C1
Communication
Heritage Vaughan – April 21, 2021
Item # 1

**Re: Heritage Vaughan Committee – April 21, 2021, 2298118 Ontario Inc.
7714 Yonge Street, City File DA.14.009; Reginal File SP-V-016-14**

7714 YONGE STREET
VAUGHAN ONTARIO

TREE PRESERVATION PLAN

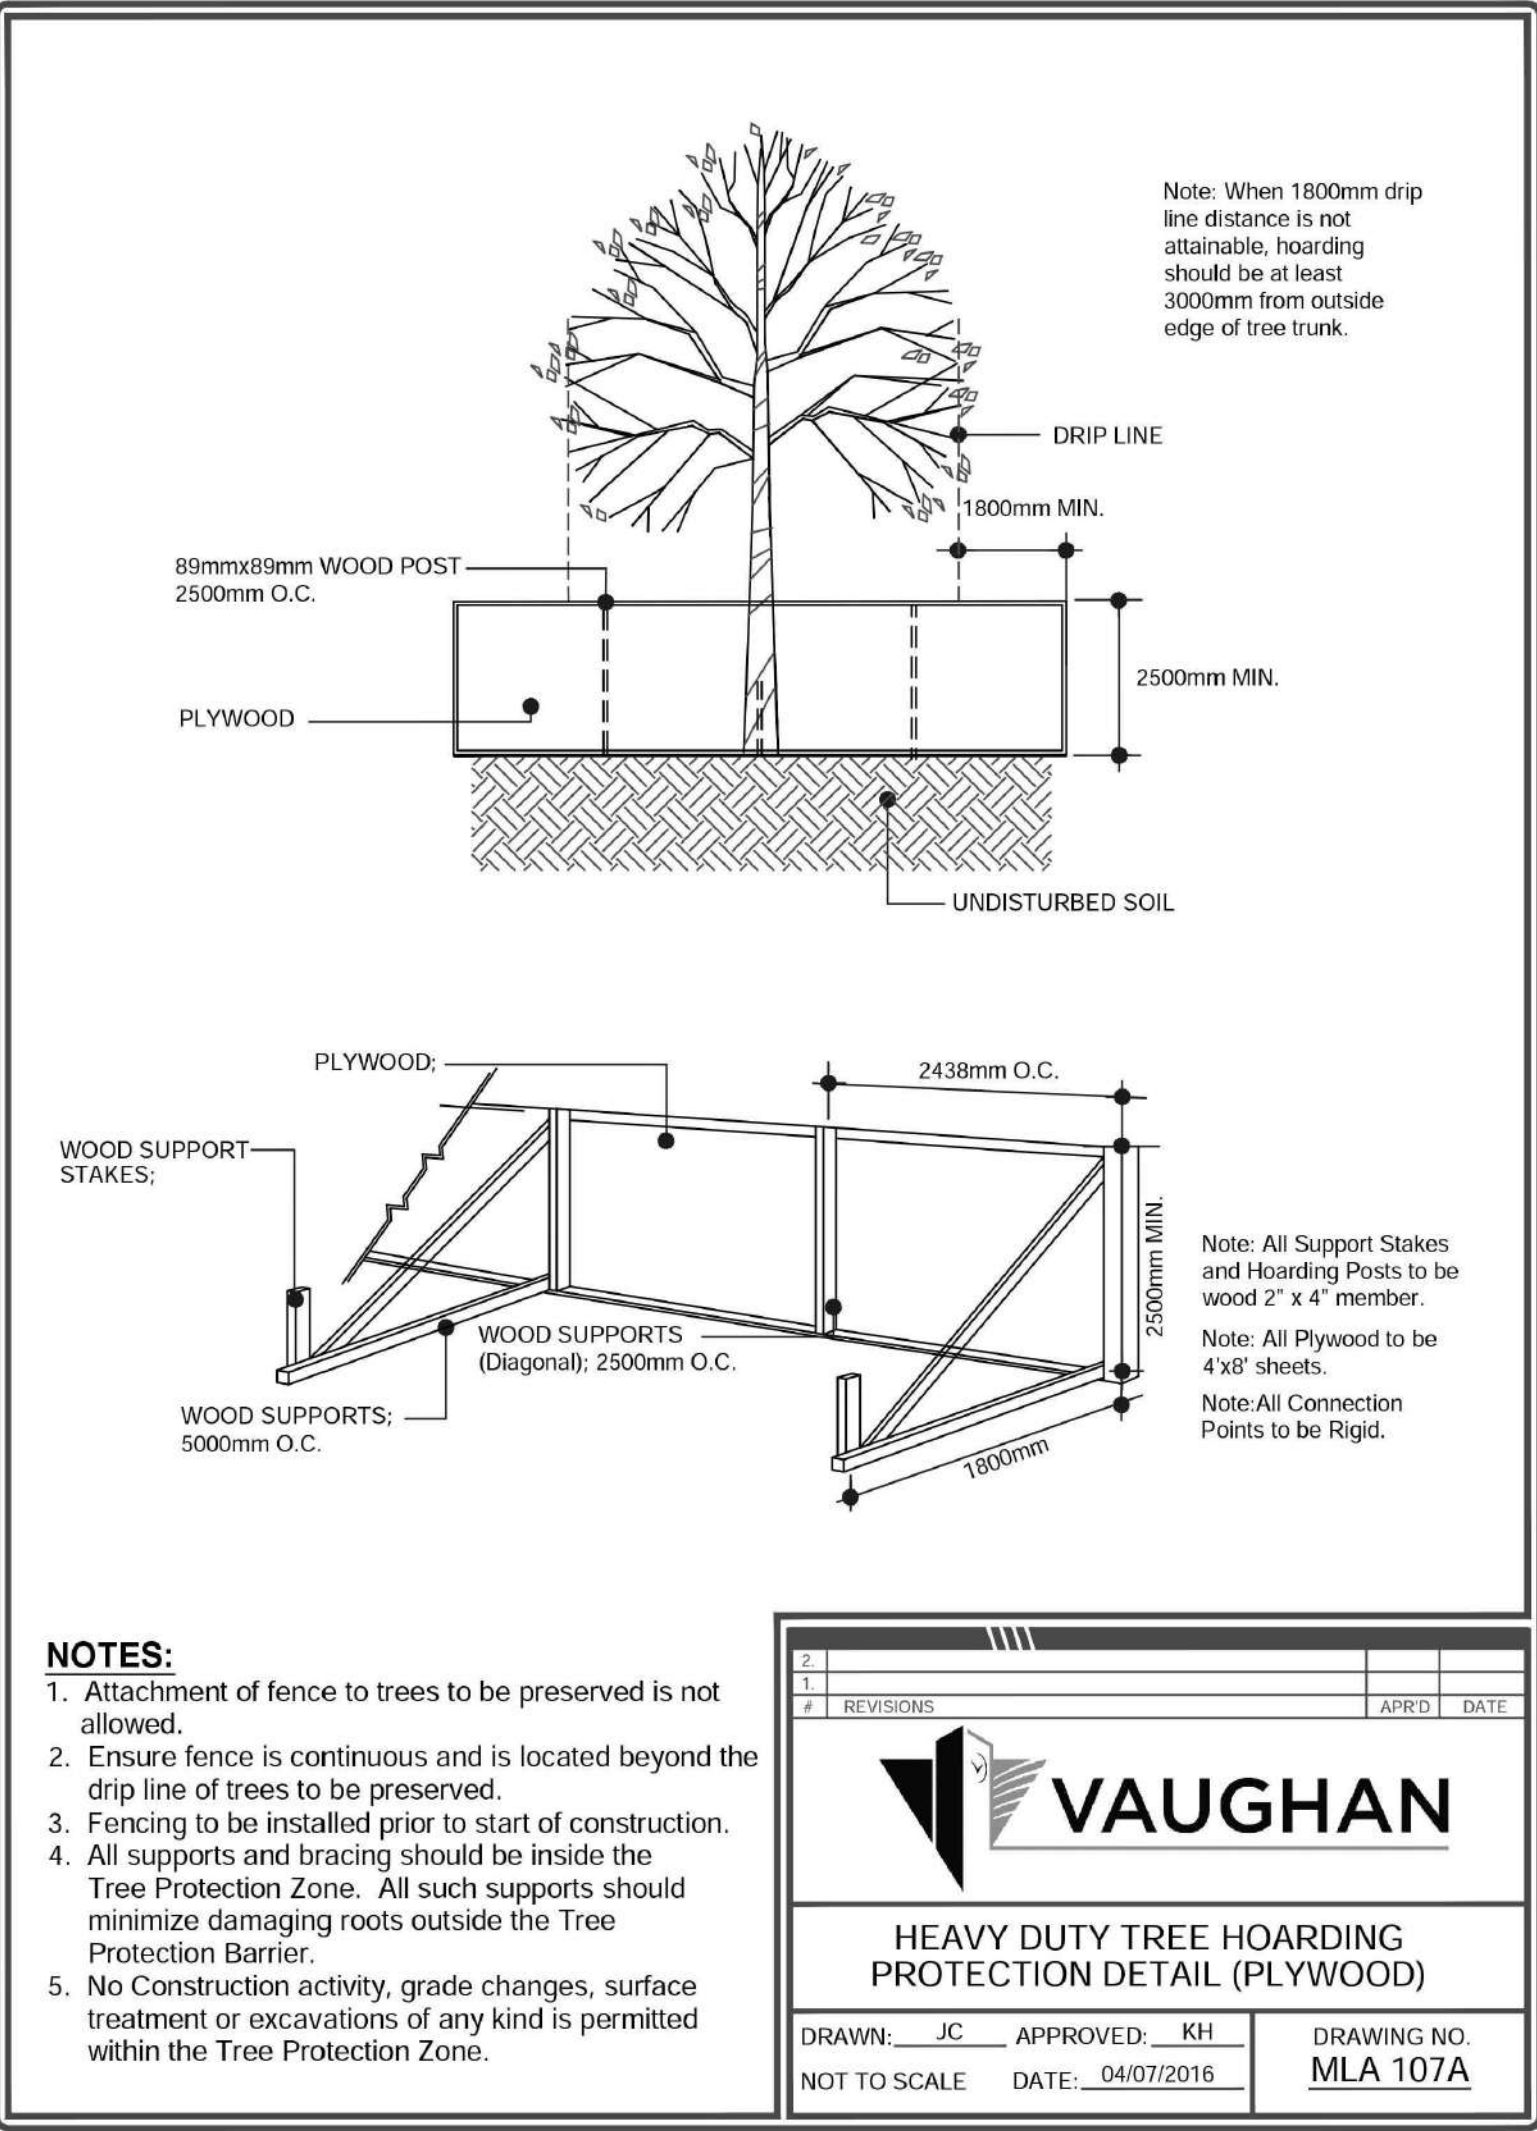
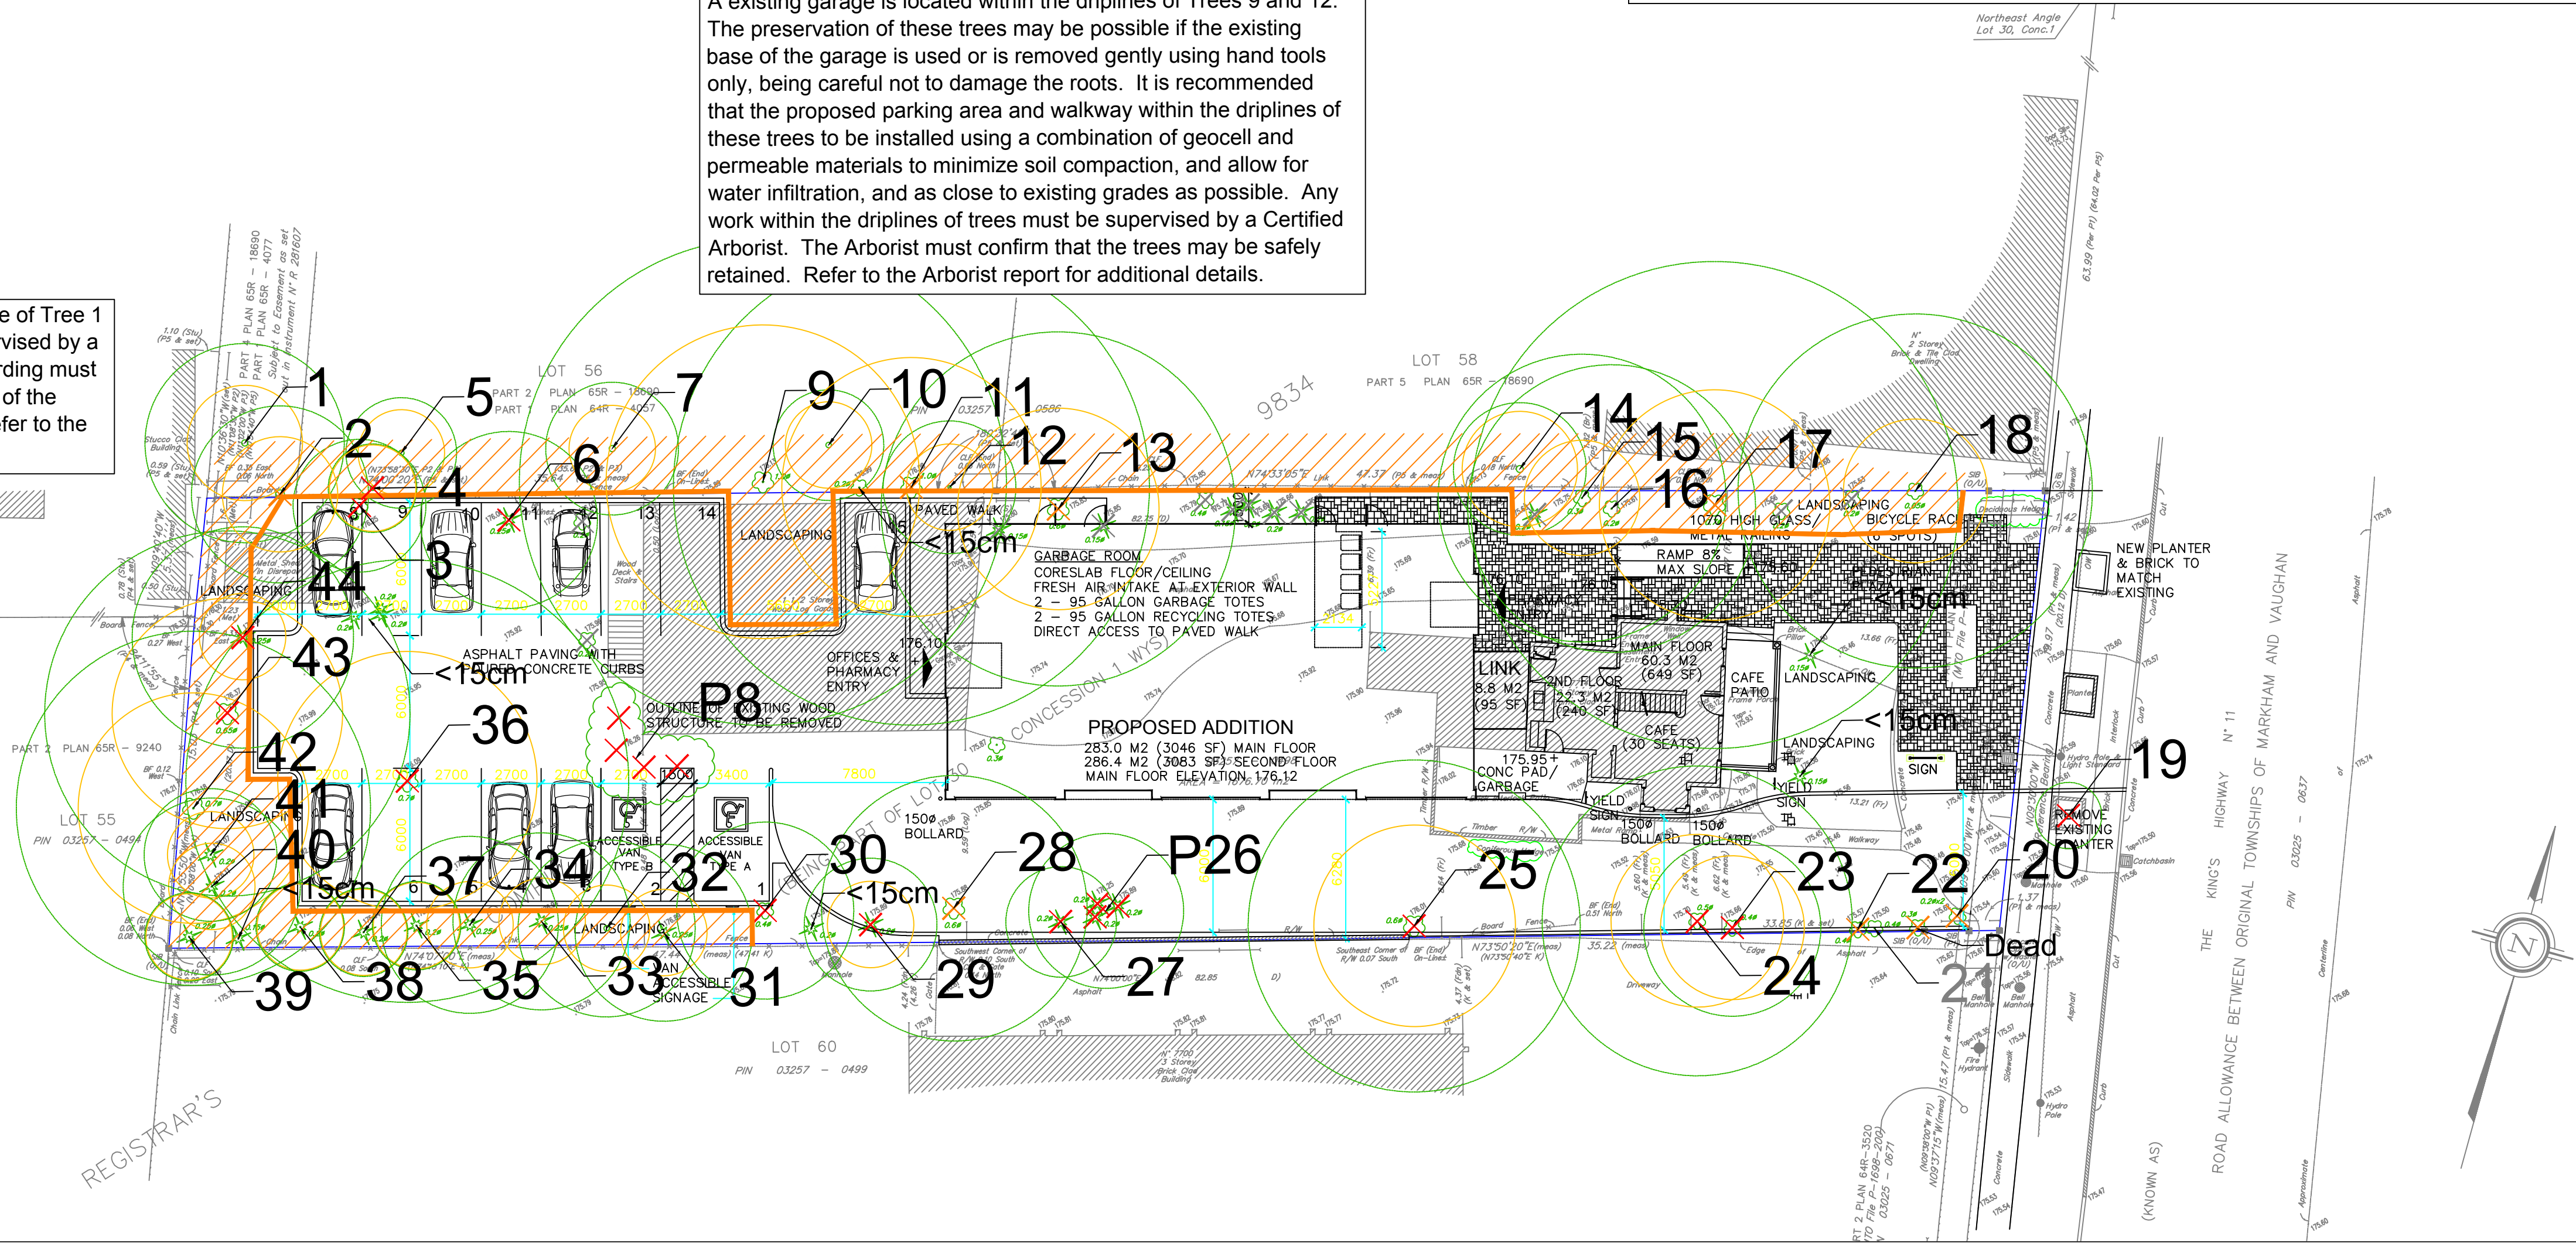
There were a number of comments raised at the meeting related to preservation of the trees on the site. As you are aware, we have worked diligently with staff over the last several years to retain as many of the trees on the site as possible. Steps include revisions to the site plan to preserve additional trees and the inclusion of such elements as the retention of existing concrete to protect tree roots where feasible and hand removal of these elements where retention is not possible. In addition, as outlined in the Arborist Report, the use of geocells and permeable materials is proposed. We are confident these measures will preserve as many of the trees on the site as possible.

The concrete pad located within the dripline of Tree 1 is to be removed gently by hand and supervised by a Certified Arborist. The tree protection hoarding must be installed immediately following removal of the concrete pad and prior to construction. Refer to the Arborist report for additional details.

Encroachment into the driplines of Trees 1, 12, 14, 18, 31 to 35, 37, and 38, will be required to accommodate the proposed parking area, walkway, and/or hardscape. Any required excavation should be conducted by hand, air spade or hydro-vac to expose roots for assessment and pruning. It is recommended that the proposed surfaces within the driplines of these trees to be installed using a combination of geocell and permeable materials to minimize soil compaction, and allow for air and water infiltration, and as close to existing grades as possible. Any work within the dripline of trees should be supervised by a Certified Arborist. The Arborist must confirm that the trees may be safely retained. Refer to the Arborist report for additional details.
